ASSESSMENT REPORT

EAST GUYONG QUARRY PROJECT

Access Road Modification (06_0193 MOD 1)

Figure 2: Approved and proposed quarry access road alignments
(shown as red dashed and yellow dashed lines respectively)

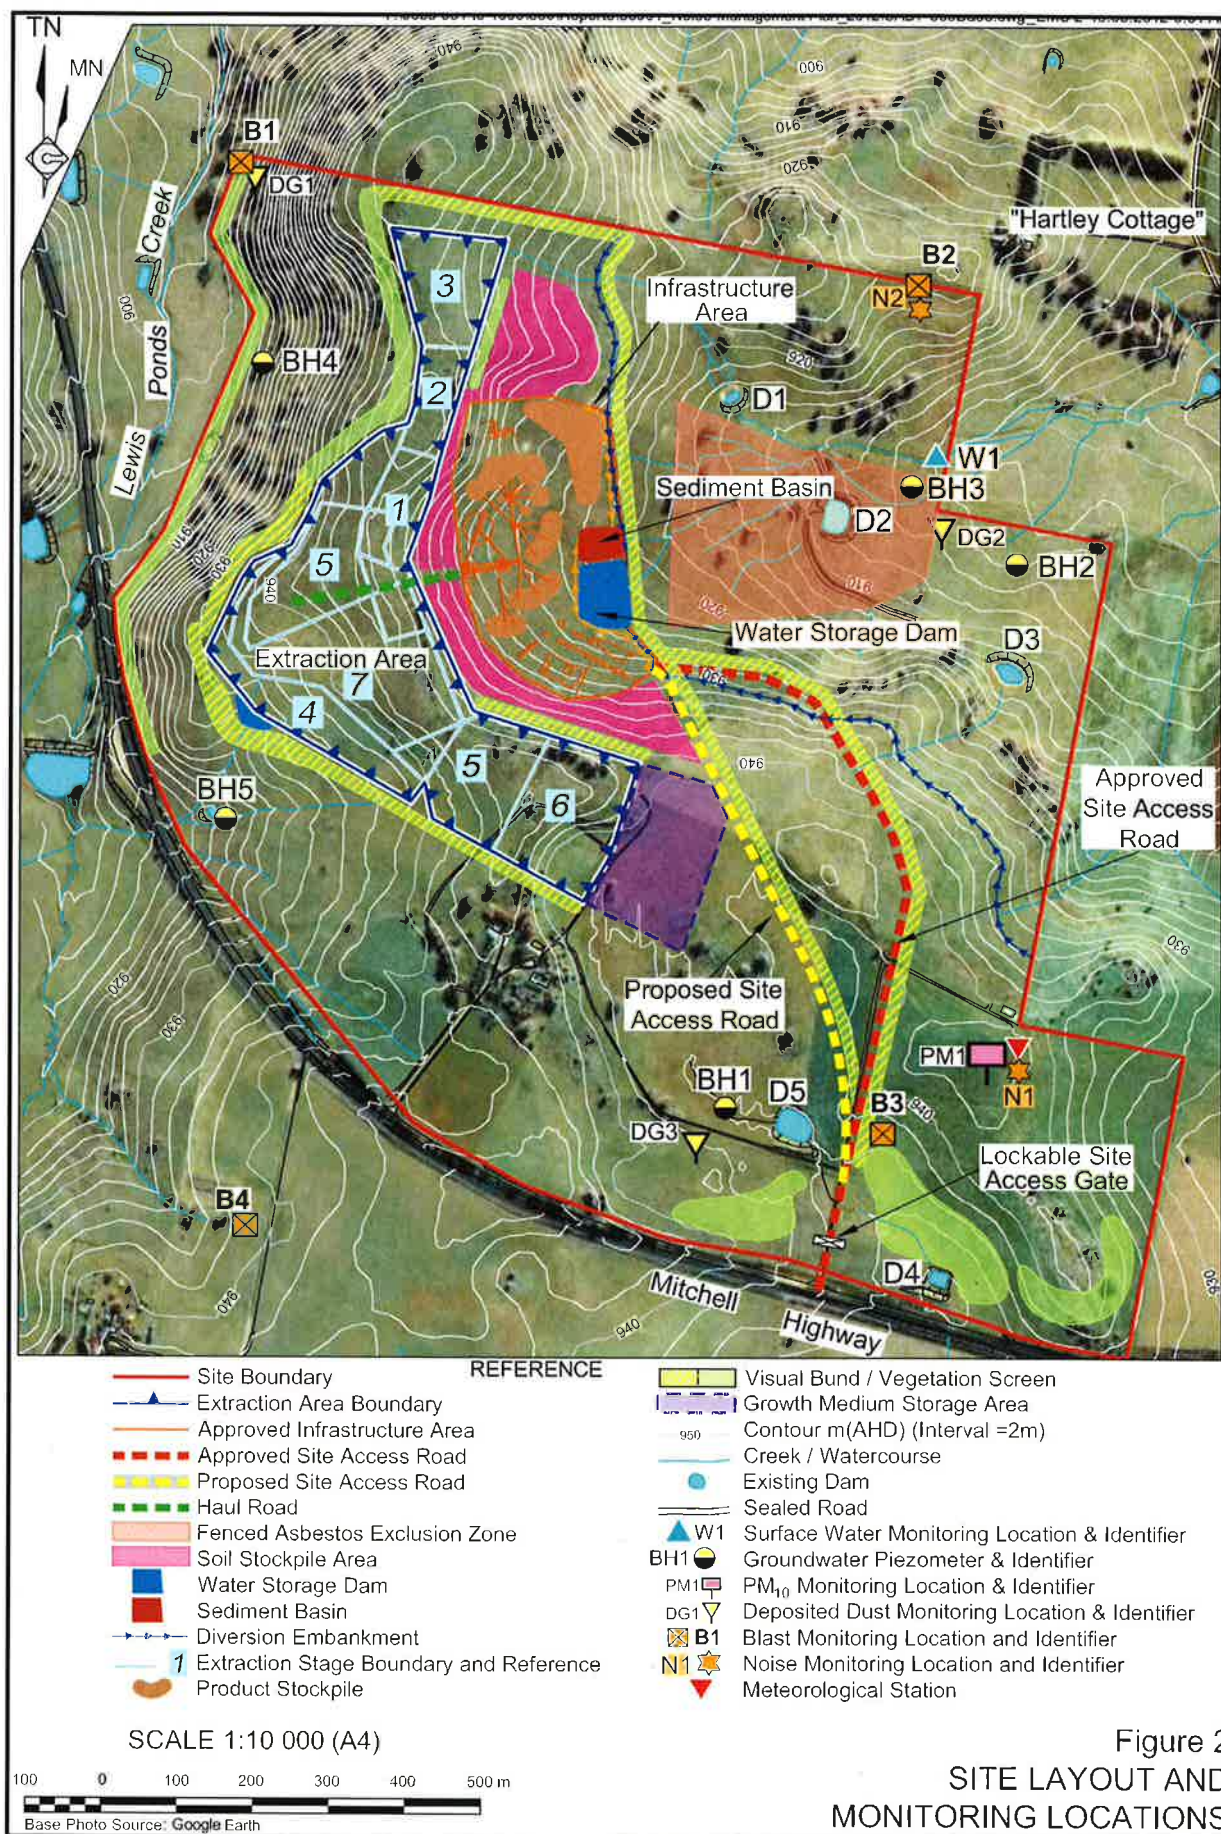
On 22 November 2012, Hanson submitted a modification application (MP 06_0193 MOD 1) under section 75W of the *Environmental Planning and Assessment Act 1979* (EP&A Act) and a supporting environmental assessment (EA). The modification application seeks to realign the approved access road from the Mitchell Highway to the quarry infrastructure area. The proposed alignment is shown as a yellow line in Figure 2.

The currently-approved access road alignment travels north from the Mitchell Highway for 700 metres (m) up and over a ridgeline, before heading in a westerly direction for 300 m along the side of the ridge to the approved infrastructure area. Hanson has since found that it could improve the efficiency of its on-site haulage, and reduce the overall impact of the approved road, by realigning the road approximately 200 m to the southwest of the approved alignment. The proposed alignment would travel more directly over the ridge, and would require significantly less cut and fill and disturbance to construct. The proposed alignment would also be 145 m shorter than the approved alignment.

| Issue | Consideration | Recommendations |
|-------------------------------------|---|---|
| <i>Naturally-occurring Asbestos</i> | <ul style="list-style-type: none">• Hanson undertook a geotechnical investigation of the proposed alignment.• The investigation found that the land affected by the proposed alignment is underlain by basalt for considerable depths, and that consequently no naturally-occurring asbestos would be likely to occur within the proposed road alignment.• The approved AMP contains appropriate procedures in the unlikely event that naturally-occurring asbestos is disturbed during the construction of the road. | <ul style="list-style-type: none">• No change to existing naturally-occurring asbestos management conditions is required. |
| <i>Visual Amenity</i> | <ul style="list-style-type: none">• Realigning the road would result in quarry vehicles being shielded from direct view of properties to the north and northwest of the site.• Approved visual amenity bunds would screen the road from views, and vegetation plantings would further reduce the visual impact of the trucks on the road. | <ul style="list-style-type: none">• No change to existing visual amenity conditions is required. |
| <i>Traffic</i> | <ul style="list-style-type: none">• The proposed modification would not change traffic levels or flows at the site or on the public road network.• The proposed modification would not affect the design of the intersection with the Mitchell Highway. | <ul style="list-style-type: none">• No change to traffic management conditions is required. |

| Issue | Consideration | Recommendations |
|----------------------|---|--|
| <i>Surface Water</i> | <ul style="list-style-type: none"> The proposed alignment is located within the same catchment as the approved road. Additional surface water impacts are unlikely to result from the proposed modification. Appropriate drainage structures would be installed to manage run-off from the road. Any changes to surface water management would be addressed in a revised Soil and Water Management Plan, which is required to be prepared under existing conditions of approval. | <ul style="list-style-type: none"> No change to existing water conditions is required. |

The Department is satisfied that the proposed modification is within the scope of section 75W of the EP&A Act. In this respect, the Department notes that there would be no change to the approved extraction methods, no increase in production, no change to processing or transportation systems, and the resulting environmental impacts would be substantially the same as (or less than) the approved development.

The Department has assessed Hanson's modification application in accordance with the relevant requirements of the EP&A Act. The Department is satisfied that the proposed modification is justified, and should be approved, as constructing the access road on the proposed alignment would result in less site disturbance and civil works than the approved alignment, and would reduce the visual impact of quarry vehicles at nearby farm residences.
